ALERT SERVICE BULLETIN

214ST-18-93

MODEL AFFECTED: 214ST

SUBJECT: SPINDLE TO YOKE BOLT P/N 214-010-262-103, SERIAL NUMBERS, INSPECTION OF.

FIGURE 1 - Main Rotor Head - Bolt Locations
Two locations, on both ends of yoke. Four bolts total per aircraft.

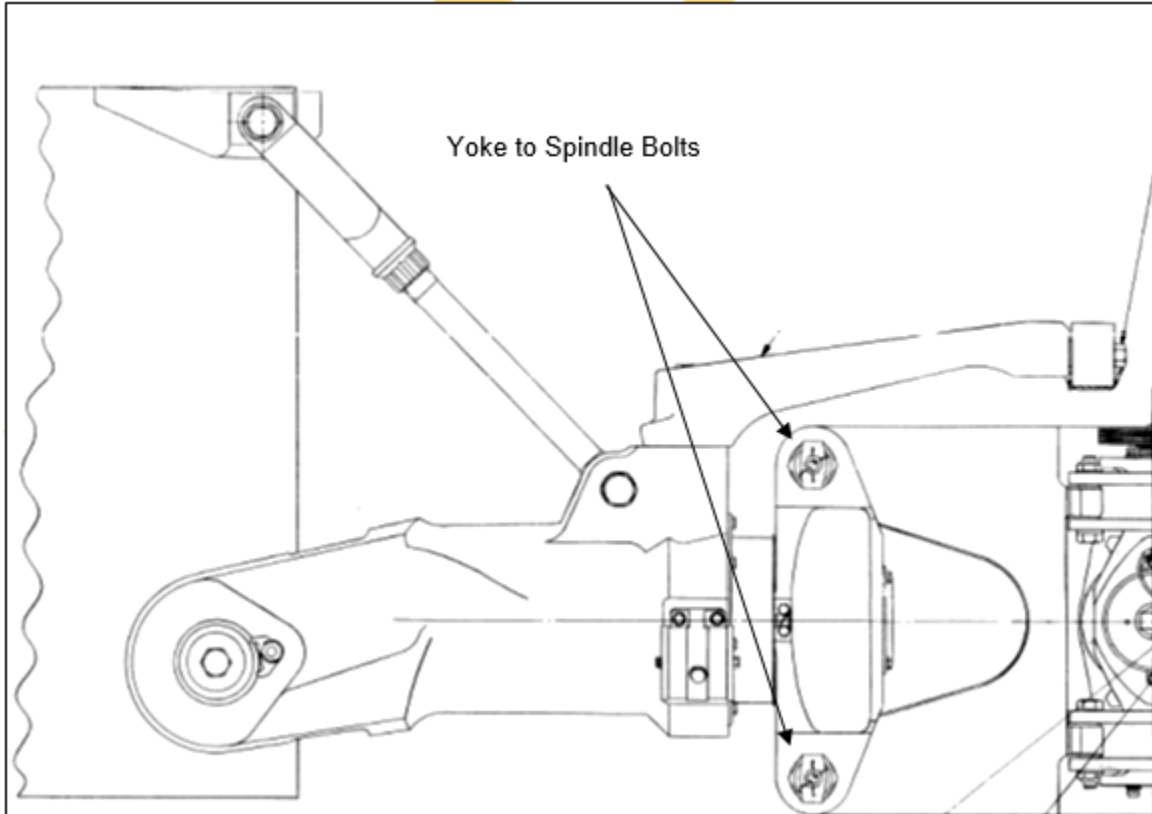
1. Prepare helicopter for maintenance.
2. Gain access to spindle yoke bolts, total of four. (Refer to Figure 1)
3. Inspect all four spindle to yoke bolts P/N: 214-010-262-103 for physical verification of serial numbers listed in Table 1. (Refer to Figure 2)
